# Errata to ICC/ANSI A117.1-1998, First Printing

Errata to ICC/ANSI A117.1-1998, Second Printing

Errata to ICC/ANSI A117.1-1998, Third Printing

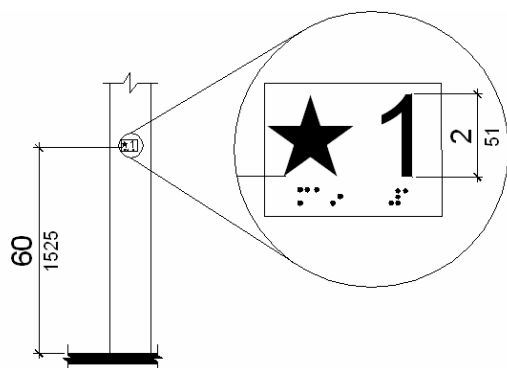
1. Page 15, Table 404.2.4.1: In footnote 2, change the metric equivalent to 305 mm
2. Page 17, Section 404.2.4.4: Typo in title (Recessed)
3. Page 23: Revise Figure 407.2.4 as follows:

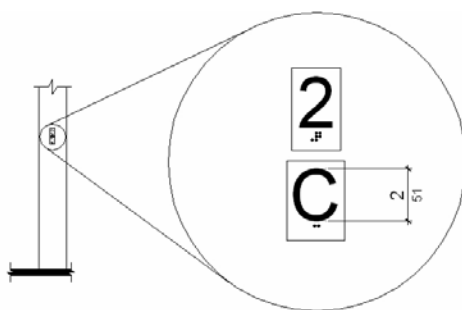
4. Page 27: Revise cross reference in Section 407.3: "…shall also comply with 407.3.1 through ~~407.3.5~~ 407.3.6 and…"
5. Page 28: Revise Figure 407.3.5 as follows:
